HARPER'S PLACE SUBDIVISION

APPLICATION NUMBER 10 DATE May 19, 2011

REQUEST Subdivision

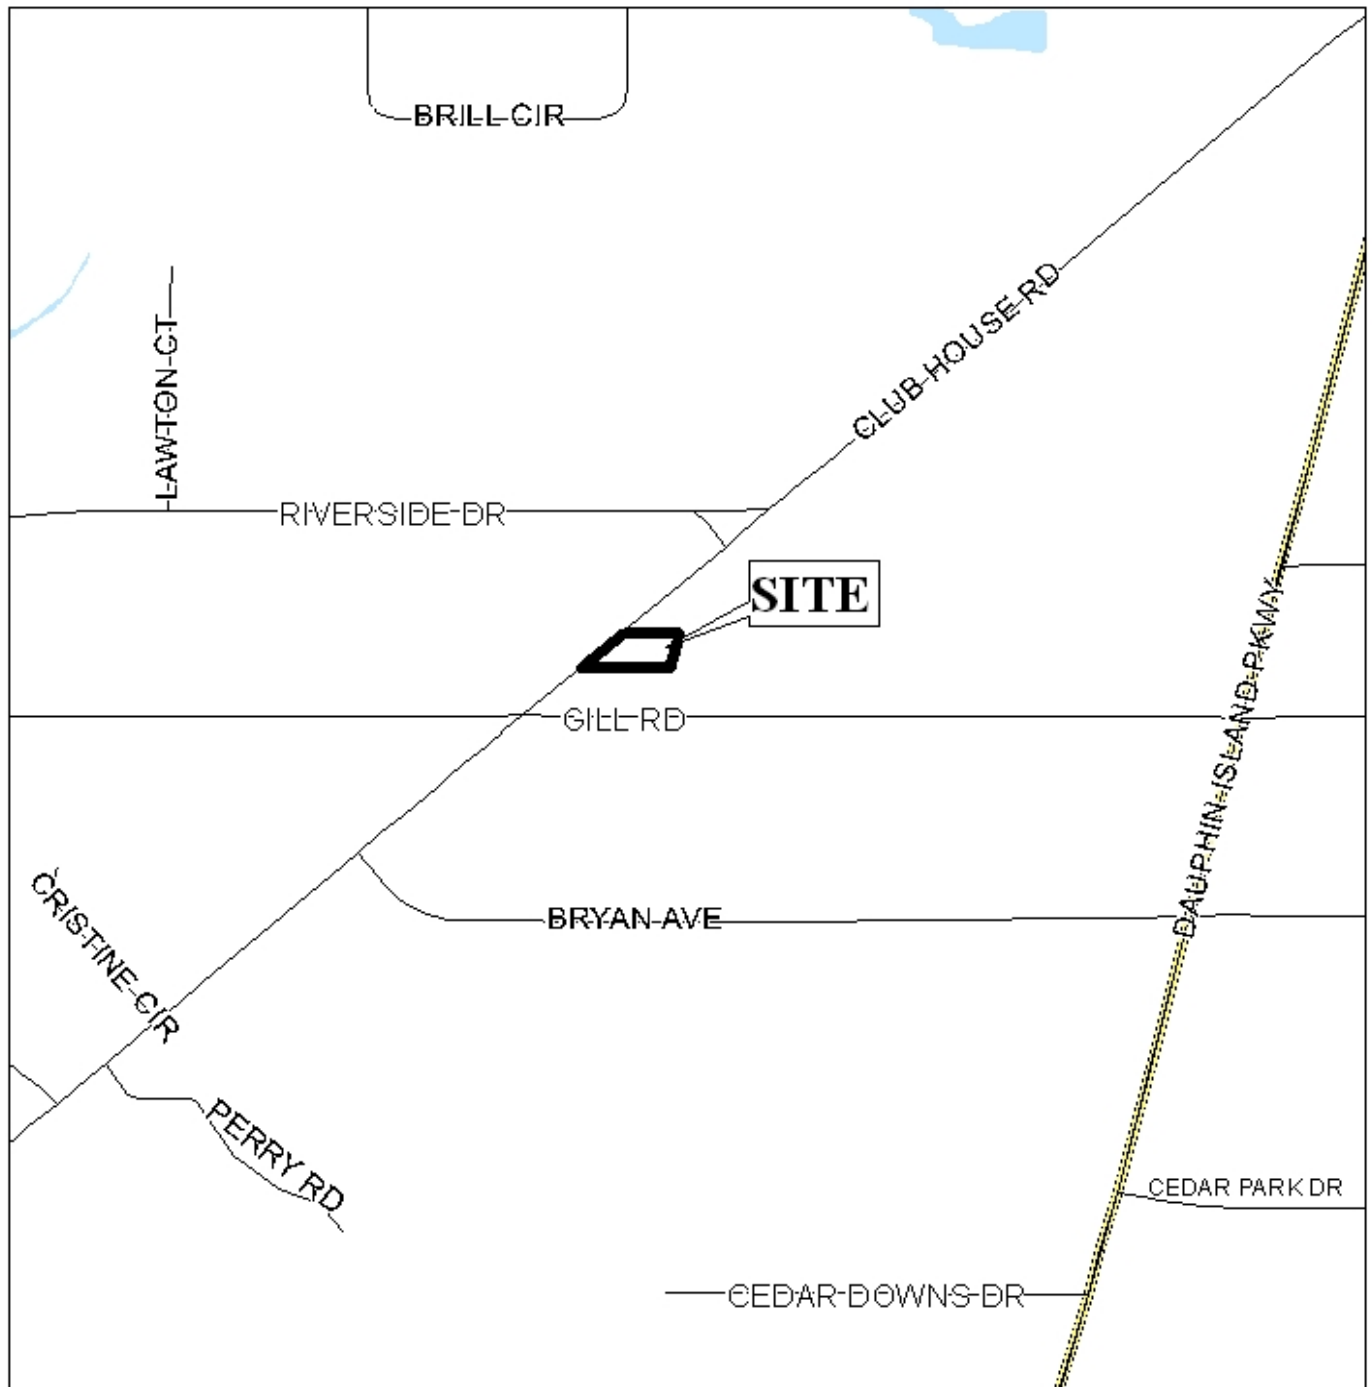
Engineering Comments: Revise the flood statement on the map to reflect "X-Unshaded" as determined by "scaling". Must comply with all storm water and flood control ordinances. Any work performed in the right of way will require a right of way permit in addition to any required land disturbance permit. Drainage from any dumpster pads cannot discharge to storm sewer; must have connection to sanitary sewer.

The proposed lot would be slightly less than 60' wide at the building setback line, and a waiver of Section V.D.2 of the Subdivision Regulations would be required. It should be noted that this parcel is the West remnant of Lot 15, Block A, Riverside Subdivision, as it was originally platted. Lot 15, and its South neighbor, Lot 14, were both severed from their Eastern portions when Breedlove Subdivision, a Resubdivision of Portions of Lots 14 and 15, Block A, Riverside Subdivision (a Planning Commission approved subdivision) was recorded in 1979. The lot would meet the minimum square footage requirements.

The proposed lot has frontage on Club House Road and the plat shows a dedication of 25' from the centerline to the City of Mobile. The plat illustrates the 25' minimum building setback line as measured after the dedication for the right-of-way. A note should be required on the Final Plat limiting the lot to one curb cut to Club House Road, with the size, location, and design to be approved by Traffic Engineering and conform to AASHTO standards.

The lot is labeled on the plat with its size in acres and square feet, and should also be labeled on the Final Plat, if approved.

With a waiver of Section V.D.2., the proposed plat meets the minimum requirements of the Subdivision Regulations and is recommended for tentative approval subject to the following conditions:

- 1) placement of the labeling of the lot with its size in square feet;
- 2) placement of the 25-foot minimum building setback line;
- 3) placement of a note on the Final Plat limiting the development to one curb cut to Club House Road, with the size, design, and location of all curb cuts to be approved by Mobile City Engineering and conform to AASHTO standards;

- 4) placement of the dedicated right-of-way;
- 5) compliance with Engineering comments (*Revise the flood statement on the map to reflect "X-Unshaded" as determined by "scaling". Must comply with all storm water and flood control ordinances. Any work performed in the right of way will require a right of way permit in addition to any required land disturbance permit. Drainage from any dumpster pads cannot discharge to storm sewer; must have connection to sanitary sewer*);
